ADDENDUM NO. 07

TO SPECIFICATIONS AND CONTRACT DOCUMENTS FOR INVITATION TO BID BIMT NEW ENTRANCE & ROADWAY JPA CONTRACT NO.: C-1951

INVITATION TO BID BIMT NEW ENTRANCE & ROADWAY

RESPONSE TO QUESTION(S)

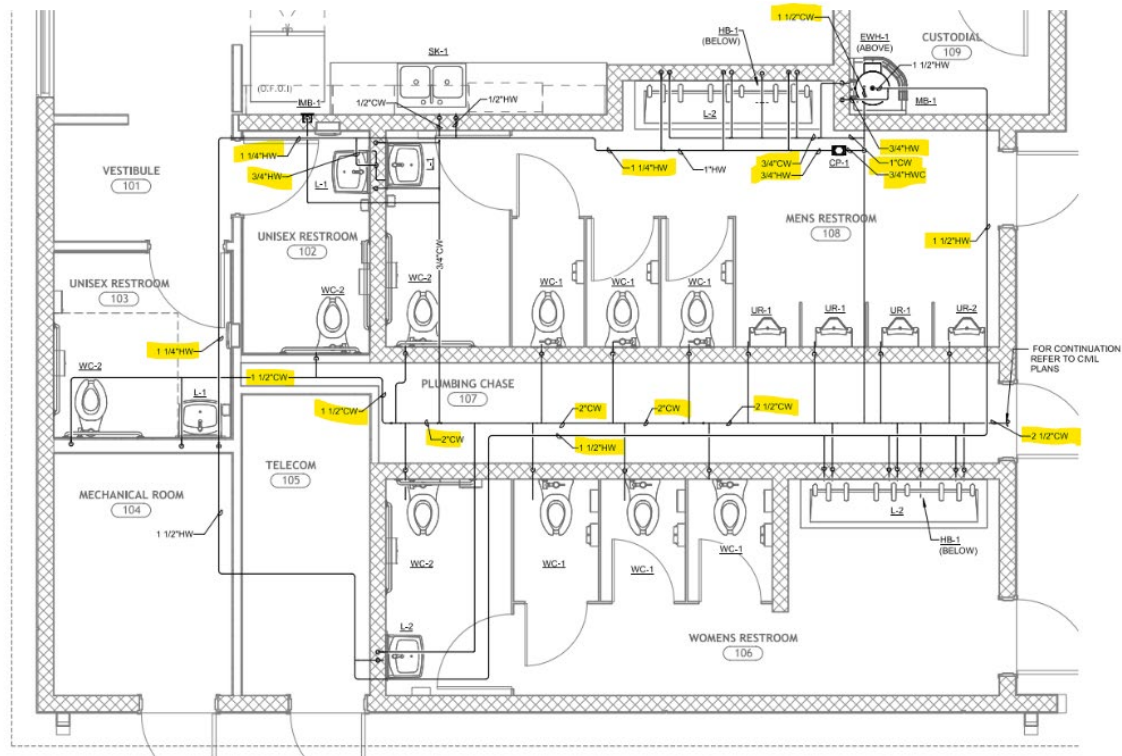
3. To go through all the new plans and specifications will take more time than one week. Also, the addendum states a new bid form was issued. It was not included. Please advise?

ANSWER: An updated bid form is issued with Addendum No. 7
